Hill of Fare Wind Farm

Additional information for Historic Environment Scotland

SLR Project No.: 405.03539.065315

13 August 2024

Figure 3-1: Sunrise

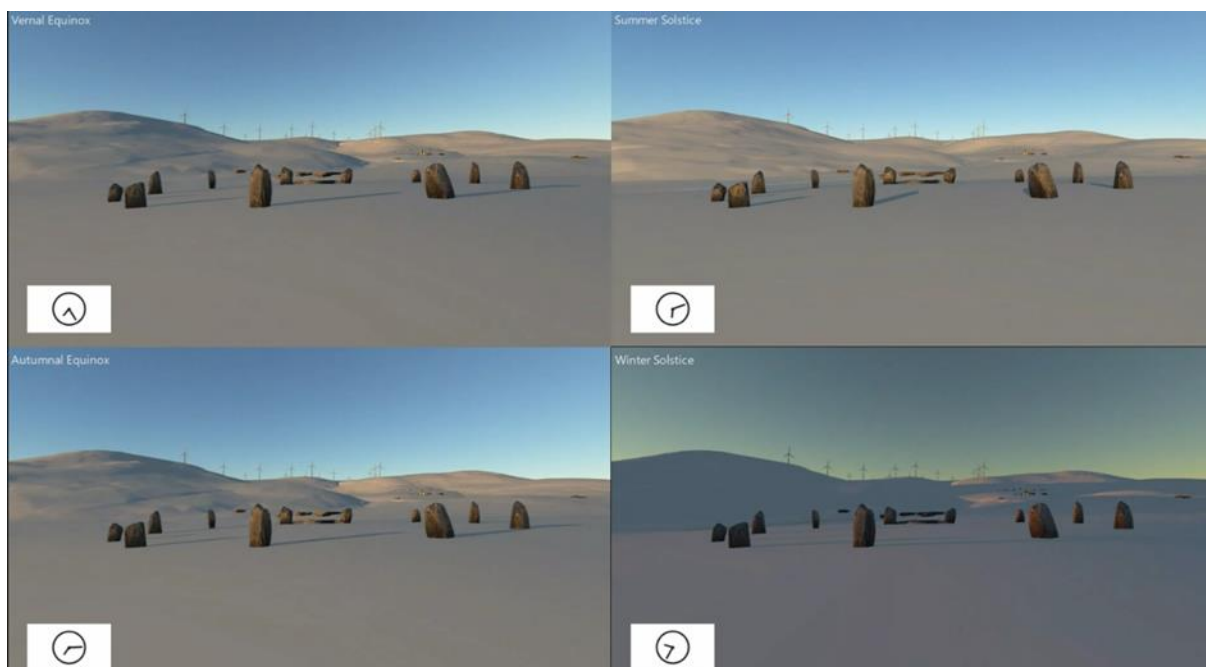
- 3.14 With reference to the 3D model video, particularly as shown in Plate 1 and Plate 2, which was produced in support of this Additional Information, it shows a variety of sunrises and sunsets at key points of the year.

3.15 Notably, the Summer and Winter Solstices and Vernal and Autumnal Equinoxes. These solar periods are often linked to Neolithic monuments such as Callanias Stone Circle (SM90054), Maeshowe (SM90209) and many others. With reference to the video, it can be shown that the only time that there may be an association with solar movements and the monument is at sunset at the winter solstice, however, the setting sun does not appear to be framed by the recumbent and as such theoretically disproves the argument of a solar association with the RCS, particularly at Sunhoney.
